## Building Permit Review Comments Response Letter:

Re: **Staff Report DSRFY2023 - 0006**  
**Starbucks**  
**5586 N Maple Grove Rd. Garden City, Idaho 83714**

Below is a list of responses to review comments for Starbucks Garden City, each followed by relevant details and actions taken.

A-1.0

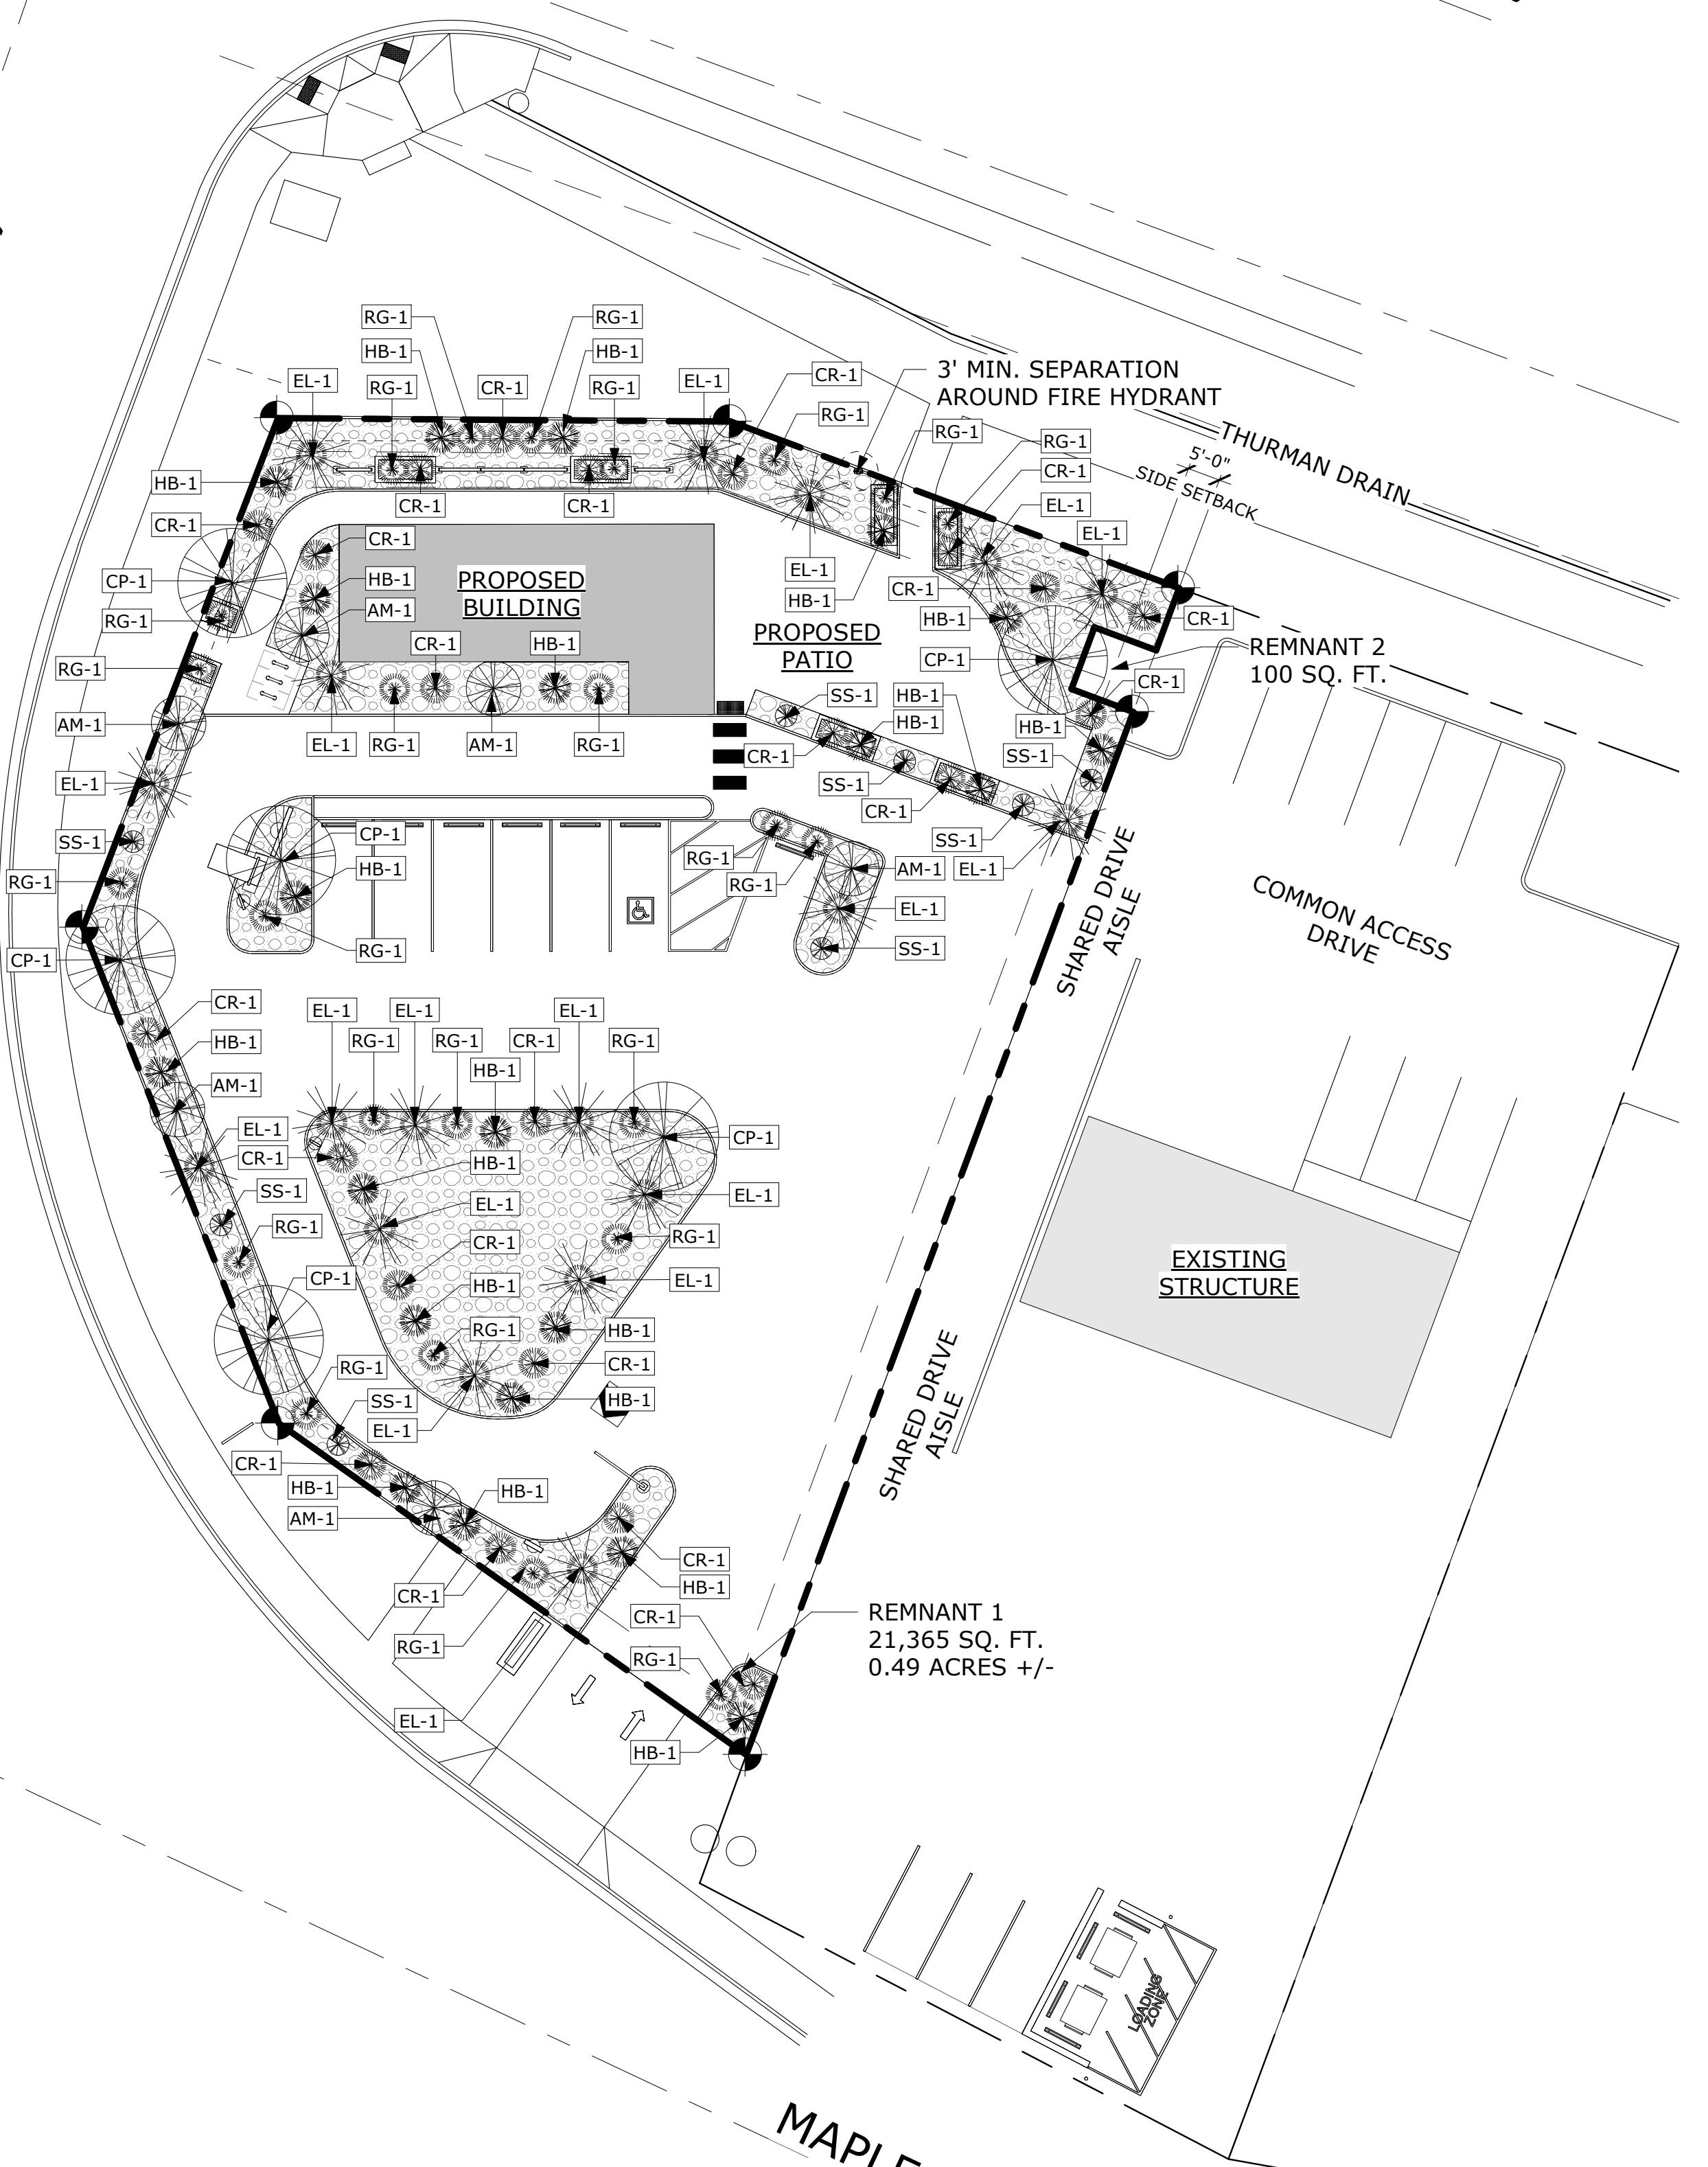
1. **8-2B-3** - The property does not appear to meet the minimum street frontage, refer to 8-4C discussion and analysis.  
*R1. Please see sheet A-1.0 for updated building orientation, which is proposed to meet the minimum street frontage requirements by utilizing the building's façade, as well as a plaza.*

2. **8-2C-13** - Stacking study has not been provided.  
*R2. Please see keynote 23 for the stacking study on sheet A-1.0.*
3. **8-2C-13** - The stacking lane and drive through window are oriented toward the front setback along Maple Grove.  
*R3. Please see updates to sheet A-1.0 which reflects proposed changes to the drive thru orientation.*

4. **8-2C-13** - Pedestrian walk up window faces internal to the development, adjacent to the parking lot and pedestrian plaza area. The building does not provide in structure seating area, as it is a drive thru only.  
*R4. Please see updates to sheet A-1.0 which reflects proposed changes to pedestrian access to the site, changing the main point of access from Chinden to Maple Grove in order to route pedestrian traffic out of the way of the drive thru.*

5. **8-2C-13** - It is unclear how wide the pathways are  
*R5. Please see updates to sheet A-1.0 which shows minimum sidewalk widths are 5', in accordance with the ADA.*

6. **8-2C-13** - Both pedestrian pathways from the existing and proposed sidewalks will intercept with the drive aisles of the project. It appears that painted stripes are indicating pedestrian crossings. Signage indicating crossing has not been shown on site plans.  
*R6. Please see updates to sheet A-1.0 which reflect changes to the pedestrian circulation throughout the site. Also, see keynote 22 for location of pedestrian crossing signage.*

7. **8-2C-13** - Not provided, the stacking lane is longer than 100'  
*R7. Please see keynote 20 on sheet A-1.0 which show changes made to include an escape lane.*

8. **8-2C-13** - Not compliant, restroom has not been provided for patrons.  
*R8. Please see keynote 24 which indicates the entrance for the proposed public restroom.*

9. **8-2C-13** - To reduce vehicle emissions, signage shall be provided advising drivers to reduce vehicle idling.

1. **8-4A-5** - The trash enclosure details have not been provided. It is unclear what the trash enclosure is made of, and what the gate looks like. It is visible from both Maple Grove and Chinden.  
*R1. See keynote 1 on sheet A-1.0 for details.*

2. **8-4A-5** - It is unclear how far the trash enclosure is from the property boundary lines.  
*R2. See updated dimensions on sheet A-1.0.*
3. **8-4C-3** - The structure does not appear to meet the street frontage requirement. 60% of the street frontage along the front setback should be occupied by a structure or plaza. The property has two streets to address, N. Maple Grove and W. Chinden Blvd. most of the site consists of landscaping and hardscaping, the structure makes up for a small percentage of the site. To meet the street frontage requirement, the structure would need to be within 5- 20' of the property boundary line, which is considered the "frontage zone". Or a plaza can be placed in-between the right-of-way and the structure to count towards the 60% requirement and increase interaction with the public ROW. A pedestrian plaza is provided; however, it is internal to the development and does not address either street. It is unclear, but it does not appear the building provides the minimum 15% glazing along the facades facing the streets. There might be blank walls.

4. **8-4C-3** - Not enough information to review. It appears that the driveway width at Maple Grove is larger than 20'.  
*R4. Please see updated dimensions on sheet A-1.0. The aforementioned driveway is existing; however, we have updated our site to reflect requirements set forth in Ordinance 1034-22.*

1. Bicycle parking spaces shall: Be a minimum space six feet (6') long by two feet (2') wide. Not enough information.  
*R1. Please see updated dimensions on sheet A-1.0.*
2. **8-4D-7** - Off street loading zone is not defined in the submitted plans. Clarification is needed. If a loading zone is provided, the above standards shall be met.  
*R2. An on-site parking and drive aisles are proposed to have a dual purpose and act as a loading zone. Please see keynote 21 on sheet A-1.0 as a reference.*

1. **8-4E-6** - This pathway is required on the subject property with a public access easement. The easement has been drafted as a condition for approval.  
*R1. Please see pathway shown on sheet A-1.0. See keynote 14 for the Thurman Drain fall protection rail, in accordance with Alternate 1 for the Chinden Blvd. South Sidewalk Project.*

*R9. See keynote 16 on sheet A-1.0 for location of idle-free signage, signage is to comply with city guidelines.*

*R3. Please see updates on sheet A-1.0, which show proposed changes to the building's orientation, and the site design, bringing the building to the frontage of the property, and providing a public plaza along the frontage as well. Refer to keynote 2 on the drawing titled PATIO (1/A-4.0), which references glazing on the frontage. Keynote 4 on the drawing title WALK up (2/A-4.1), also references glazing along the building's frontage. See general note F on sheets 4.0 and 4.1 for frontage glazing calculations.*
